# **Shearon Harris Nuclear Power Plant, Units 2 & 3**

## **COL Application**

## **Technical Specifications**

**Section A. PSTS and Bases Differences from the DCD GTS and Bases (HAR COL 16.1-1)**

FIGURE 4.1-1 Low Population Zone and Site Boundary Map

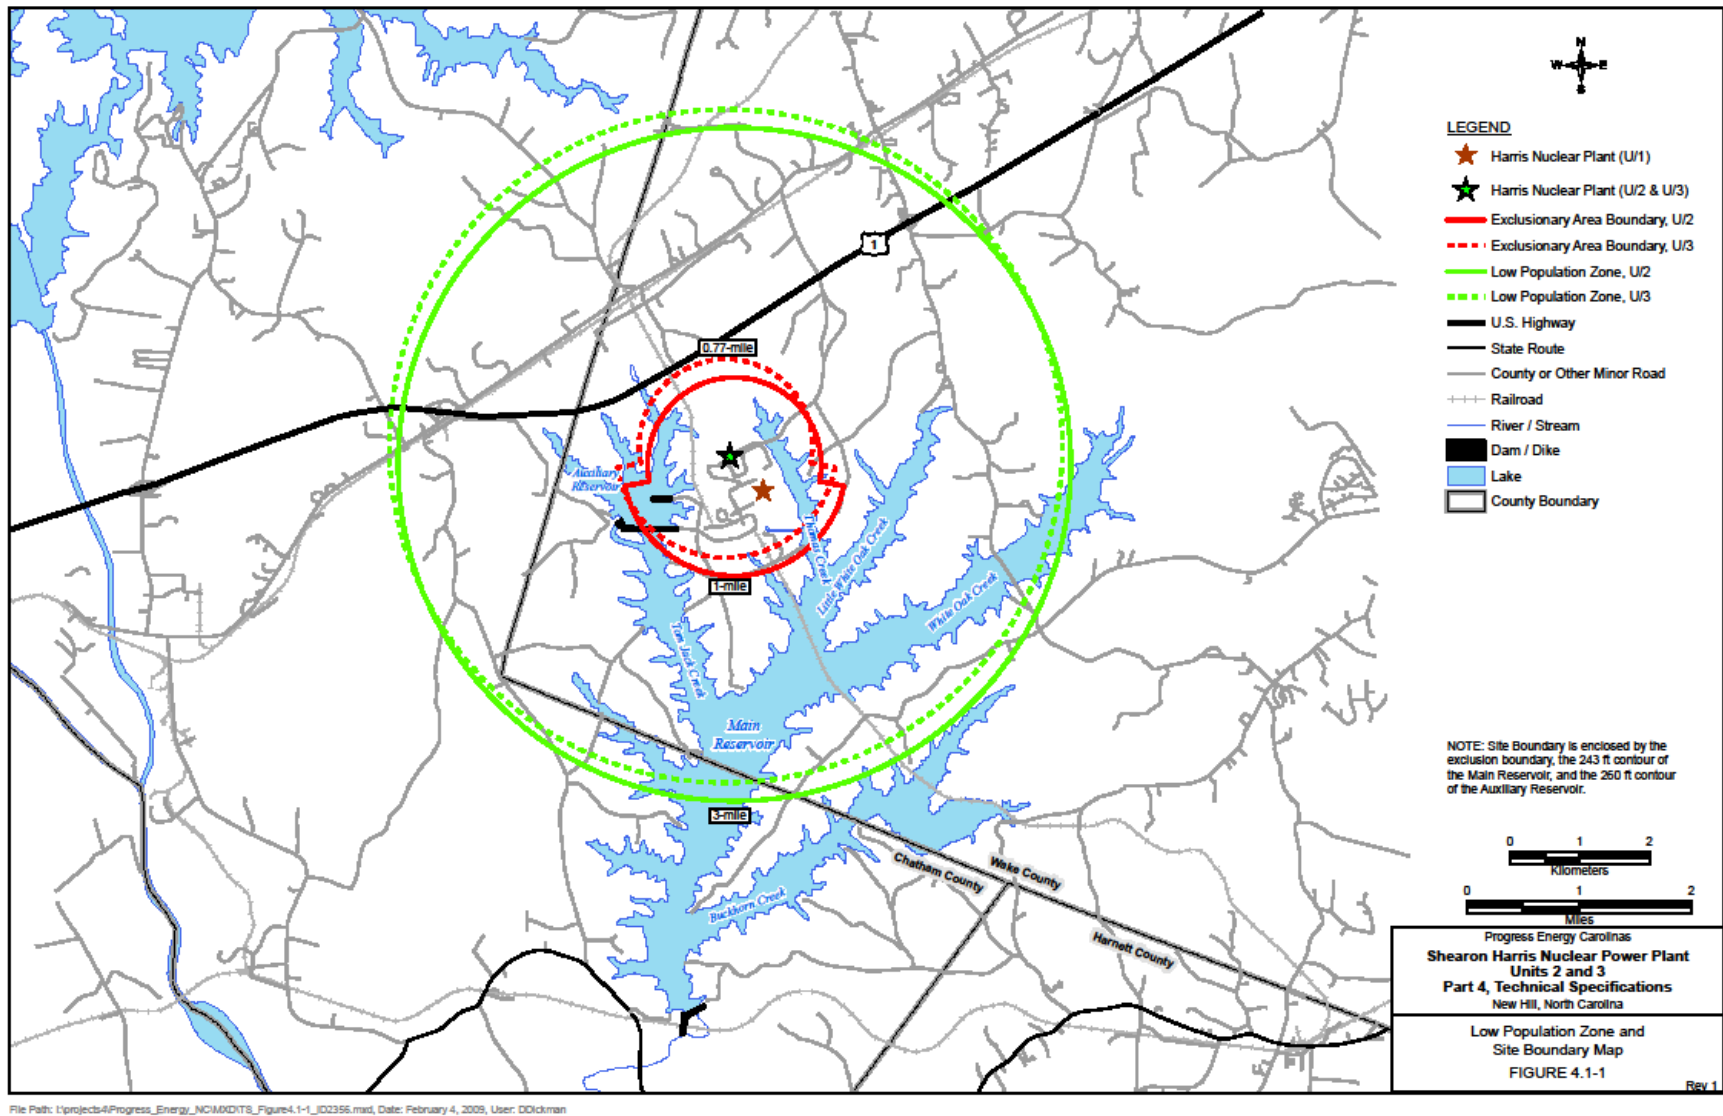
GTS 4.1.1     The bracketed information in the GTS reads:  
[This information will be provided by the combined license applicant.]

Replace the bracketed information in the GTS with the following:  
The Site Boundary is shown in Figure 4.1-1.  
The Exclusion Area Boundary is shown in Figure 4.1-2.

GTS 4.1.2      The bracketed information in the GTS reads:  
[This information will be provided by the combined license applicant.]

Replace the bracketed information in the GTS with the following:  
The LPZ is defined by the 3 mile radius from the site center point as shown in Figure 4.1-1.

Justification:  
Bracketed information is replaced to establish Site Boundary and Exclusion Area Boundary for HAR consistent with the descriptions identified in FSAR Sections 2.1.1.2 and 2.1.1.3.

Bracketed information is replaced to establish the LPZ for HAR consistent with the descriptions identified in FSAR Section 2.1.3.4.

Figure B 3.6.8-1 (page 1 of 1)  
Time Prior to Coolant Inventory Boiling

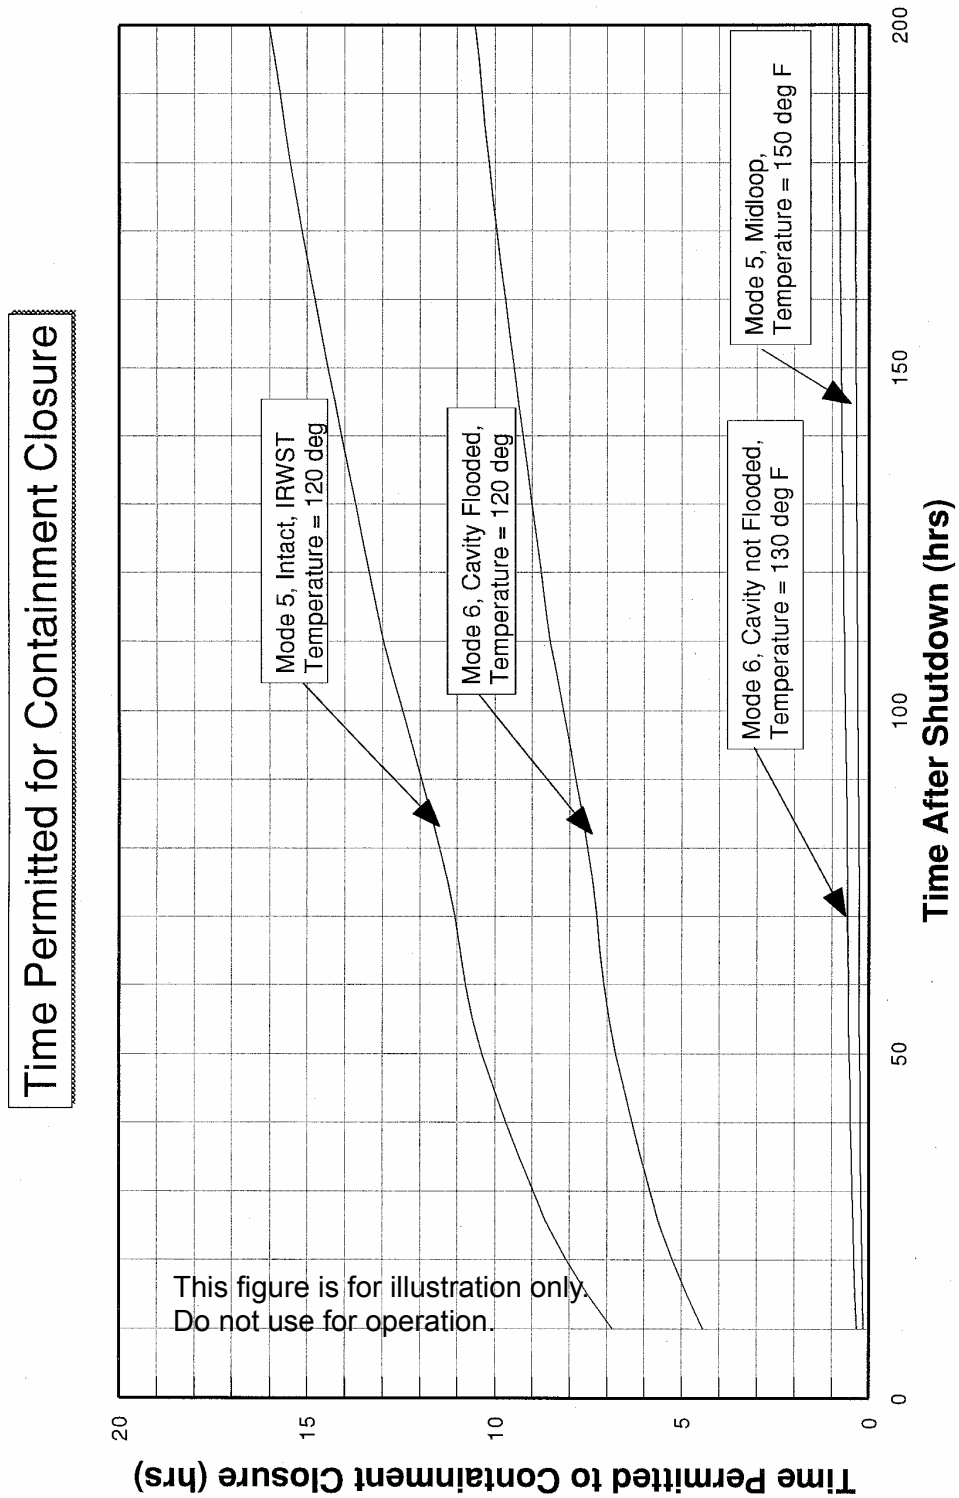
- GTS B3.6.8      The Bases for Specification 3.6.8 contain a bracketed figure which addresses the anticipated time prior to coolant inventory boiling under various conditions.

- Remove the reviewer note in the PSTS. There is no replacement language.
- Justification:  
The information is applicable as provided since no major departures from the certified design have been taken.
